**Car Stereo  
Service Bulletin**

**Model:** CDX-R77, CDX-R79

**No. 137R1**

**Subject:** Intermittent, No Play

**Symptom:**  
(12)

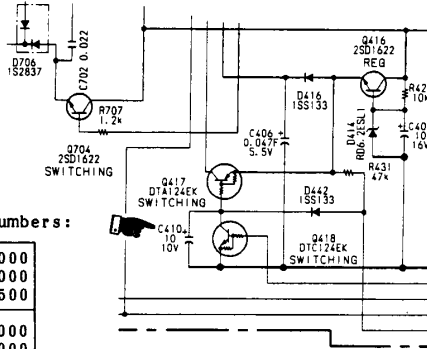
If the ignition is turned Off (ACC lead HIGH to LOW), while playing a CD, and then ignition is turned On, no functions will be accepted and there will be no display indication.

**Solution:** Please replace capacitor C410 with a new value as shown below:

Ref. No.	Former Part	New Part	
		Description	Part Number
C410	10 $\mu$ F/10V	22 $\mu$ F/16V	1-124-234-00
